COMMUNITY DEVELOPMENT AGENCY

TRANSPORTATION DIVISION

SUBJECT: Addendum No. 2
U.S. 50/Silva Valley Parkway Interchange – Phase 1
PW 12-30647, CIP No. 71328

EROSION CONTROL PLAN
 SCALE: 1"=50'
EC-2

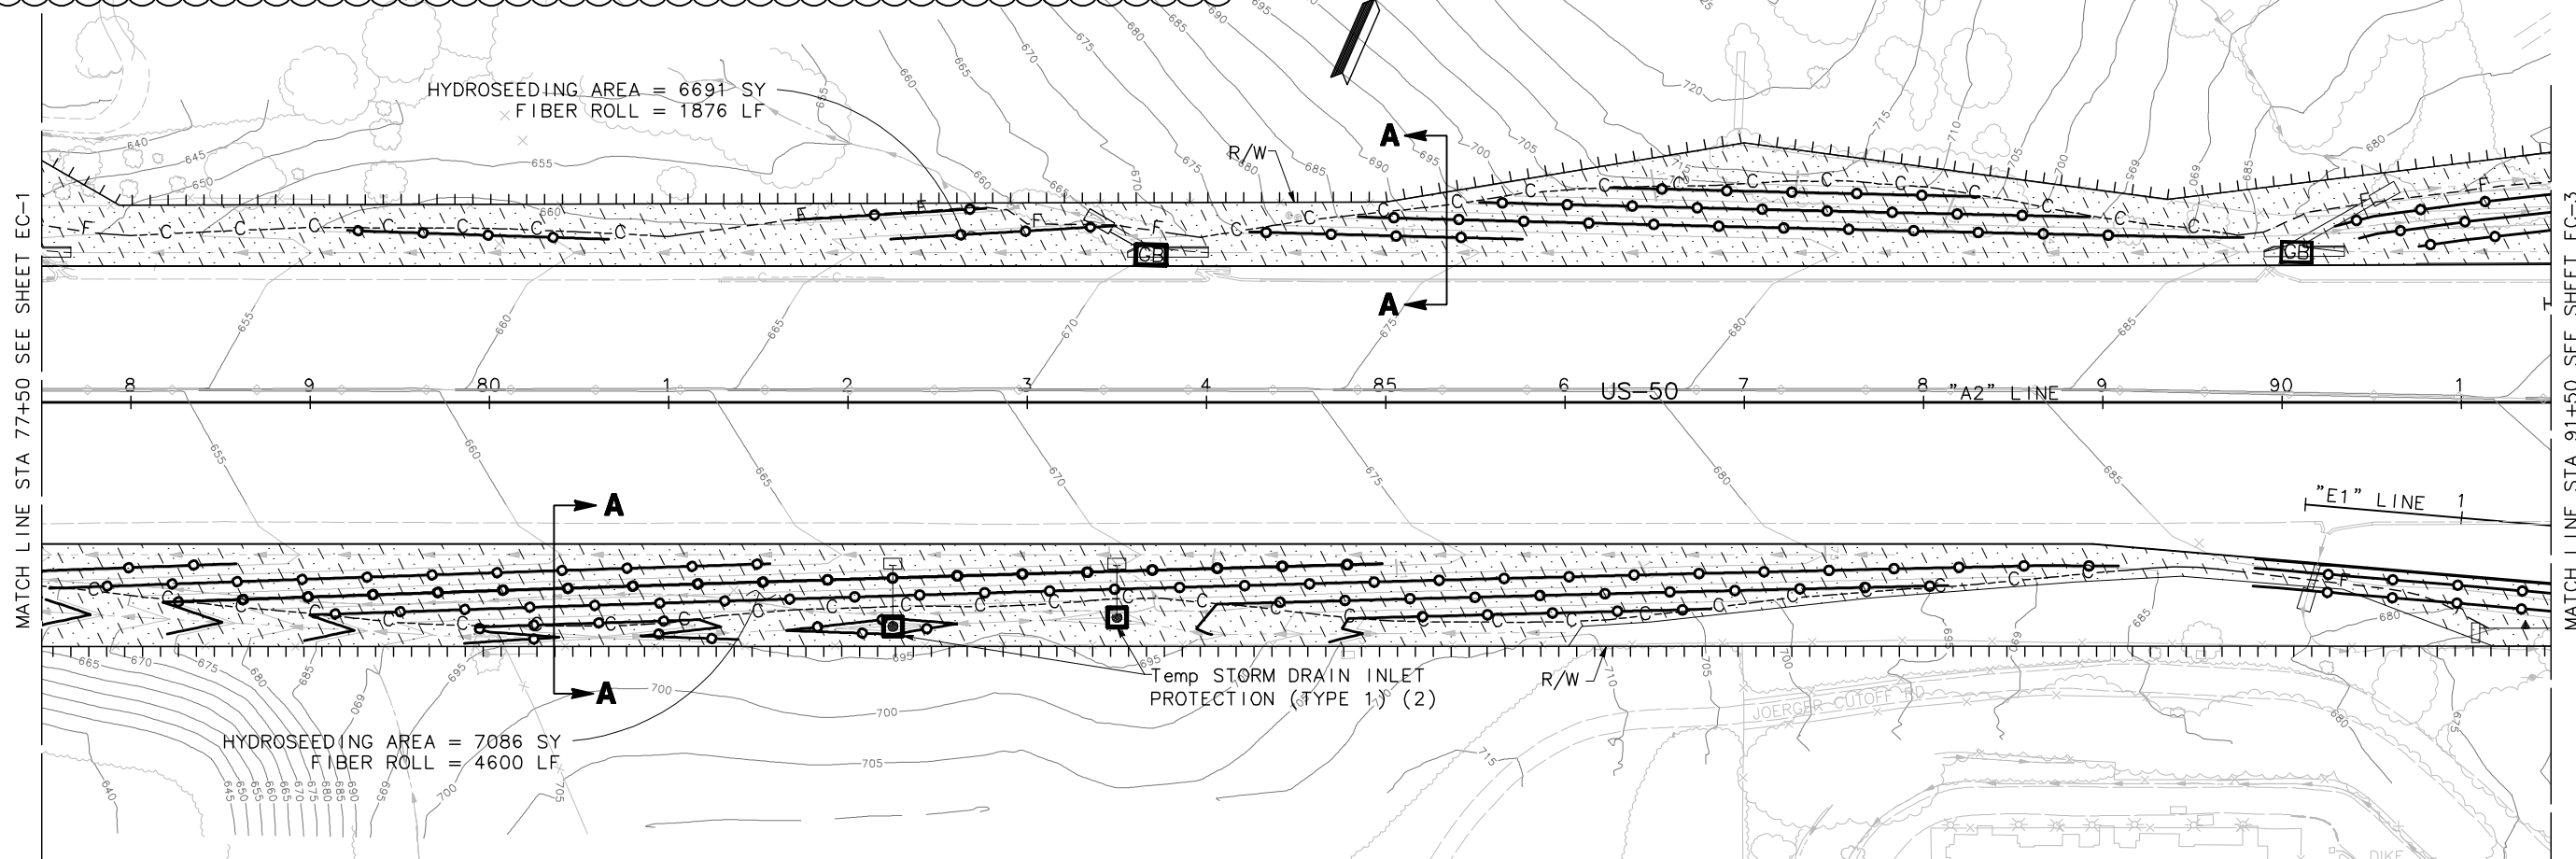
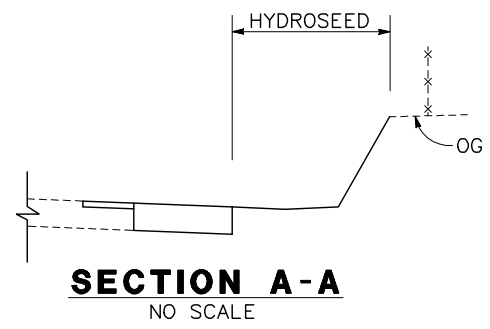
| 2. 9. | Plan sheet EC-2 (sheet 85); SP-88 | Refer to response to Bidders' Inquiries No.4 Item 4.6: Bidders are instructed to replace Plan sheet 85 with revised Plan sheet 85 attached to this Addendum. Bidders are instructed to replace section 20-7.02D(1)(d) of the Standard Specifications and section 21-2 "BIOSWALE" of the special provisions with Attachment C attached to this Addendum. Add the following to SP-88 under section 21: "Add to section 21-1.04: Straw and hydromulch are paid under Hyrdoseed." |

| MARK | DATE | DESCRIPTIONS | BY | CH'D |
|-----------|------------|------------------------------|-----|------|
| △ | 09-04-2013 | SEE MIX AND HYDROSEED TABLES | JMN | DWM |
